# Recall Bulletin

## F/CMVSS NONCOMPLIANCE RECALL

**SUBJECT:** Front Safety Belt Anchor Pretensioner Installation

**MODELS:** 2009-2010 Chevrolet Impala

### Seat Belt and Anchor Pretensioner Correctly Installed

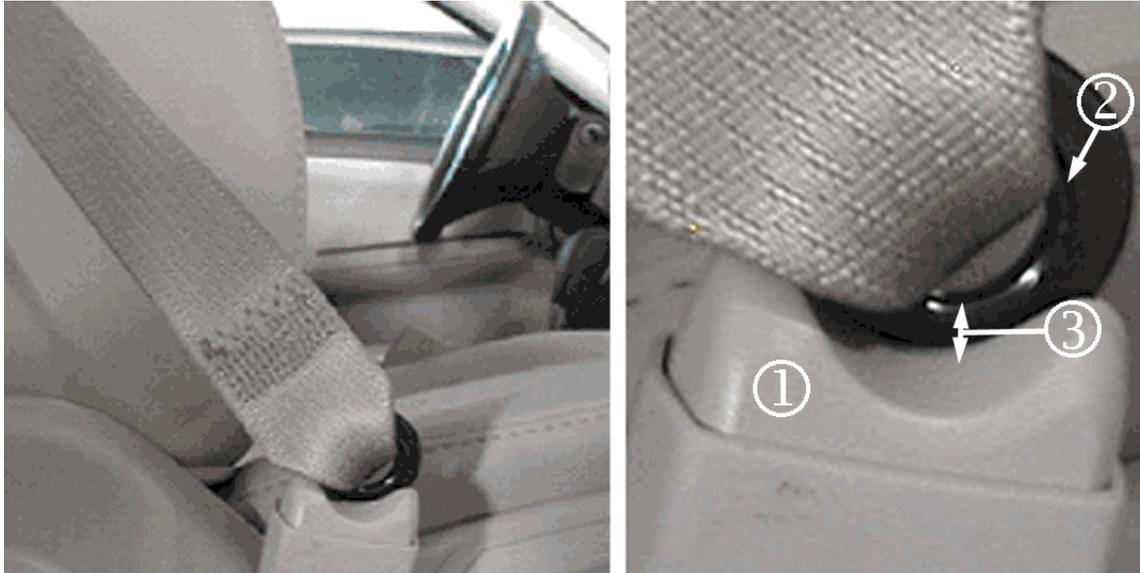
There is a small gap (3) between the anchor linkage plate ring (2) and plastic cover (1). You should only see the anchor linkage plate ring and a small portion of black metal between the bottom of the anchor linkage plate ring and plastic cover.

### Seat Belt and Anchor Pretensioner Incorrectly Installed

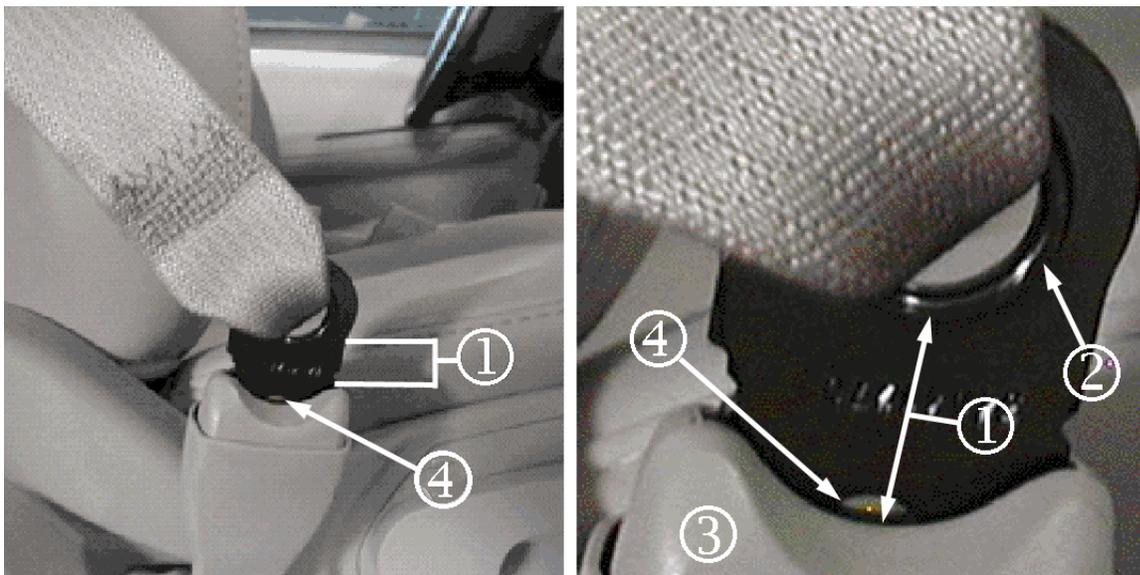
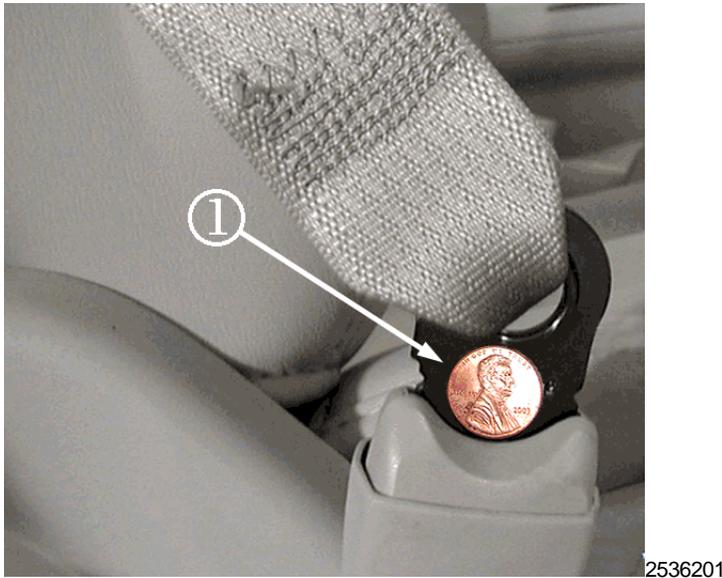
There is a large gap (1) between the anchor linkage plate ring and plastic cover. A portion of the anchor plate hole (4) may be visible. There will be approximately 19 mm ( $\frac{3}{4}$  in) of black metal visible between the bottom of the anchor linkage plate ring (2) and plastic cover (3).

If you can stick a penny (1) between the anchor linkage ring and plastic cover, the seat belt and anchor pretensioner are incorrectly installed.

#### Label Facing Door

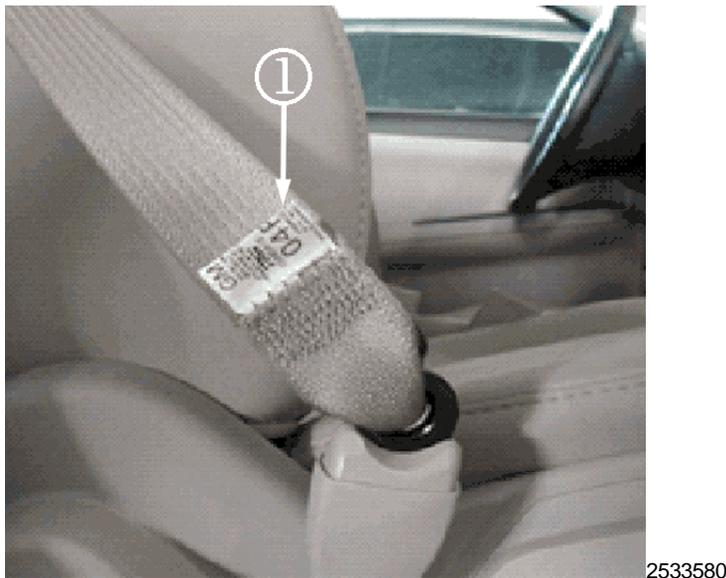
If the seat belt label (1) is facing the front door of the vehicle, the seat belt and anchor pretensioner are incorrectly installed. The seat belt label must face the seat back.

**(A) Anchor Linkage Cover (1) and Cover Sleeve (2) (B) Sleeve Pulled Down Below Anchor Linkage Cover (C) Location of Anchor Linkage Cover Screw (3). Illustration shown with the Seat Belt and Anchor Pretensioner Correctly Installed.**

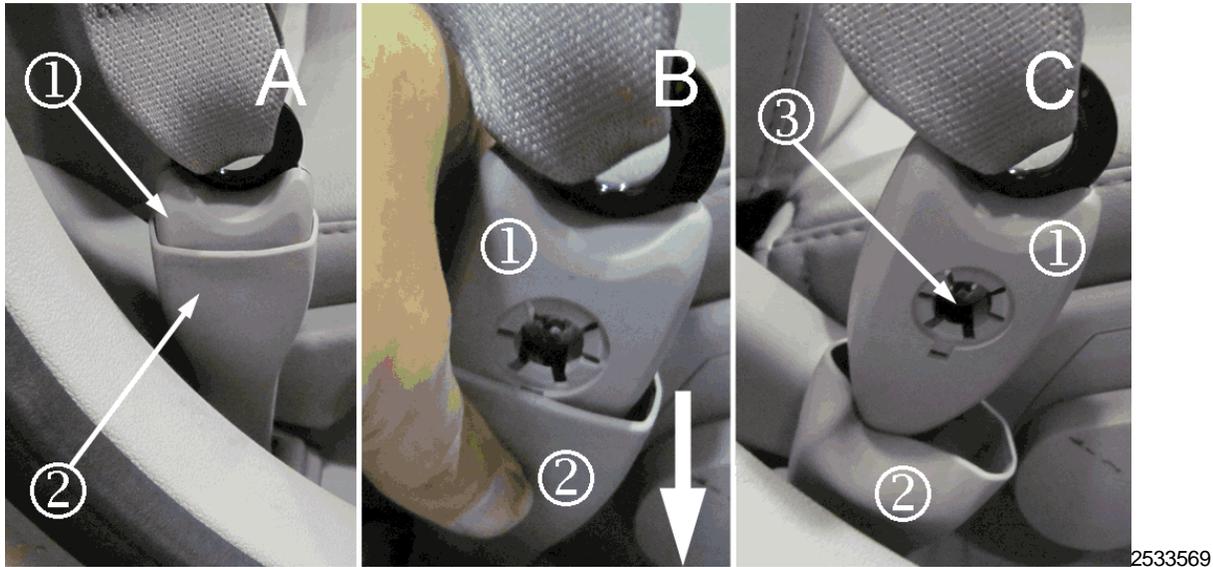
1. Determine if the seat belt and anchor pretensioner are correctly installed.
  - If the seat belt and anchor pretensioner are correctly installed, no further action is required.
  - If the seat belt and anchor pretensioner are NOT correctly installed, proceed to Step 2.

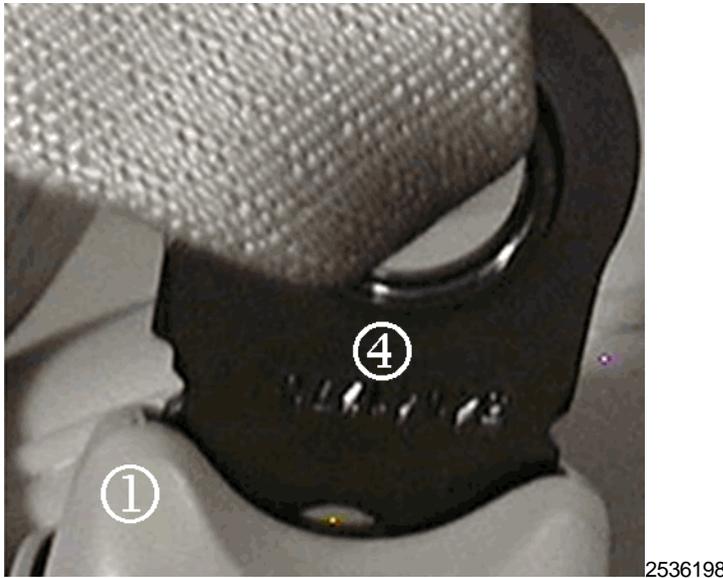
2. Pull the sleeve (2) down below the anchor linkage cover (1).
3. Remove the anchor linkage cover screw (3) by loosening the screw. Push the screw through the hole using the small access hole on the opposite side of the anchor linkage cover (1).

4. Determine the condition of the anchor linkage plate and seat belt.
  - If the anchor linkage plate (4) is not fully installed and the seat belt is also twisted, remove it from the anchor linkage cover (1) and rotate the anchor linkage plate (4) so that the seat belt has no twists and the label faces the seat back. Reinstall the anchor linkage plate (4) into the anchor linkage cover (1). Ensure the anchor linkage plate (4) is fully seated. Insert linkage cover screw and tighten to 8 N·m (71 lb in).

- If the anchor linkage plate (4) and seat belt are correctly oriented but the anchor linkage plate (4) is NOT fully installed, push the anchor linkage plate (4) down until it is fully seated. Insert the linkage cover screw (3) and tighten it to 8 N·m (71 lb in).

- If the anchor linkage plate (4) was fully installed but the label is facing the door, remove the anchor linkage plate (4) from the anchor linkage cover (1) and rotate the anchor linkage plate (4) so that the seat belt has no twists and the label faces the seat back. Reinstall the anchor linkage plate (4) into the anchor linkage cover (1). Ensure the anchor linkage plate (4) is fully seated. Insert the linkage cover screw and tighten to 8 N·m (71 lb in).

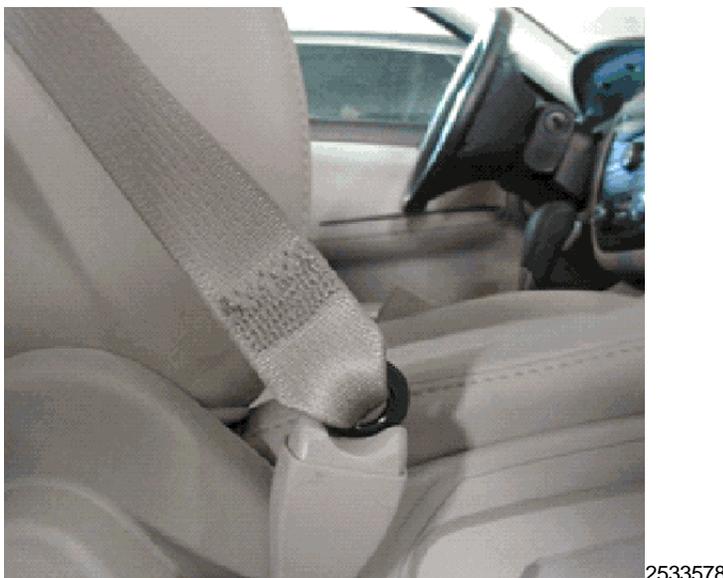
5. Push the sleeve up over the anchor linkage cover as shown in illustration.
